SUBJECT LAND: 64 – 78 Trenerry Crescent Abbotsford

TRENERRY WORKPORT 70 TRENERRY CRESCENT ABBOTSFORD 3067

Agenda Page 6
Attachment 2 - PLN20/0646 - 64 - 78 Trenerry Crescent Abbotsford - Decision Plans

Referral Comments – PLN20/0646 – 64 – 78 Trenerry Crescent Abbotsford

Attachment 3 - PLN20/0646 - 64 - 78 Trenerry Crescent Abbotsford - Landscape Plans

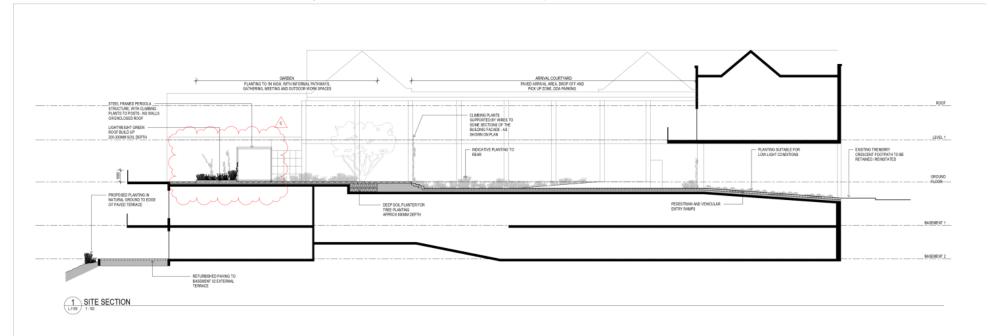
Use of plants that are not locally indigenous and have the ability to naturalise and can unintentionally spread into the Yarra River riparian corridor river, negatively impacting on biodiversity values.

Under no circumstances can *Hedera helix* be used. It's highly invasive and will naturalise in the riparian corridor.

The planting palette includes many species that are not locally indigenous. The table below outlines a palette of local indigenous species that are suggested as replacements for the species listed in the planting palette.

The following species listed in the planting palette are suitable for use provided the genetic origin is sourced less than 10km from Abbotsford and within the Victorian Volcanic Plains Bioregion:

- Carex apressa
- Ficinia nodosa
- Chrysocephalum apiculatum
